4. Teal Bay Subdivision Pattison Addition KPB File 2023-098

# ITEM #4 - PRELIMINARY PLAT TEAL BAY SUBDIVISION PATTISON ADDITION

KPB File No.	2023-098
Plat Committee Meeting:	September 11, 2023
Applicant / Owner:	Wayne L & Lynette M Pattison of Kenai, Alaska
Surveyor:	Mark Aimonetti / Edge Survey and Design, Inc
General Location:	Moose Run Rd, Nikiski, Nikiski APC

#### **STAFF REPORT**

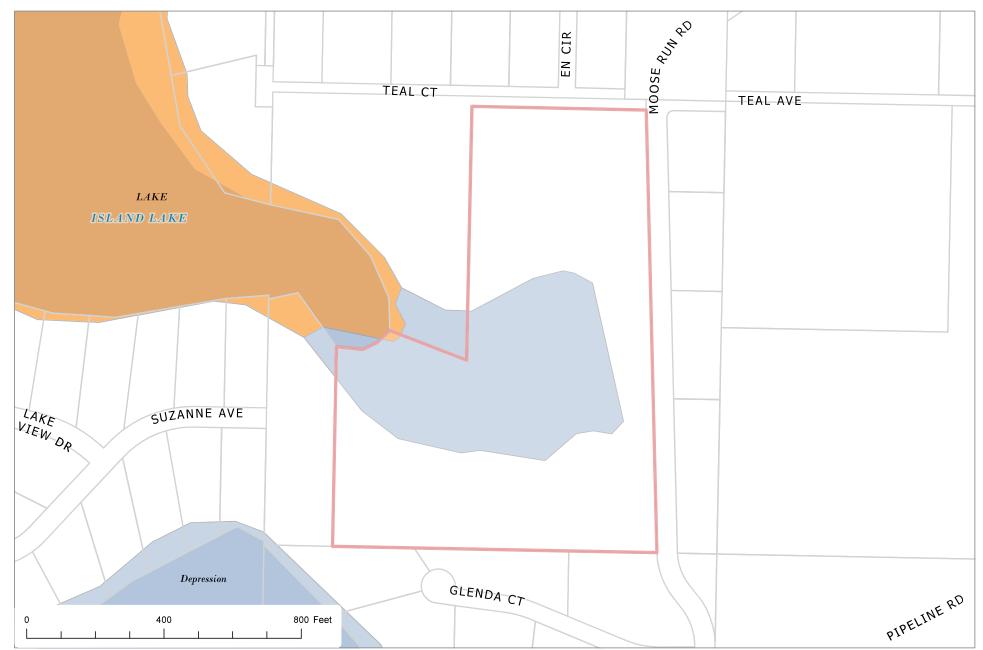
The block does not close or contain compliant lengths. There is a lake to the west and low wet land in the middle of this property making a dedication difficult. **Staff recommends:** the plat committee concur that an exception is not needed as a dedication is not possible to improve the block.

The proposed plat has steep slopes toward a low wet area basin near Island Lake that are shown on the drawing. **Staff recommends:** the top and toe of any steep terrain remain on the final plat.

KPB satellite imagery indicates this property may contain wet areas. **Staff recommendation**: place a note on the final plat indicating any person developing the property is responsible for obtaining all required local, state, and federal permits, including a U.S. Army Corps of Engineers wetland determination if applicable.

Over head utility line shown on the plat is referenced to note 9. Wording of note 9 should be changed from 'existing *communication* line' to 'existing *electric* line'.

HEA has requested the overhead line along the south boundary of the plat be located and any portion inside the boundary be shown and a plat note added stating, "The existing overhead powerline is the centerline of a 30-footwide electrical easement, including guys and anchors, granted this plat".

Correct plat note 6, references to river should be changed to lake.

Correct the numbering of the plat notes.

Correct the year in the Plat Approval note.

Update KPB No to 2023-098.

Change NW1/4 to NE1/4 in location info.

Add Lynette M to owners and add middle initial L to Wayne.

Staff recommendation: Change Teal Avenue on the west to Teal Court.

Staff recommendation: Remove T8N

**Staff recommendation:** On adjacent properties, remove the word "plat" and add KN in front of the plat filing. Add Suzanne to the lake to the southwest.

J. Block and lot numbering per KPB 20.60.140, approximate dimensions and total numbers of proposed lots; **Staff recommendation:** There are two Lot 2 shown on the plat, correct one of them.
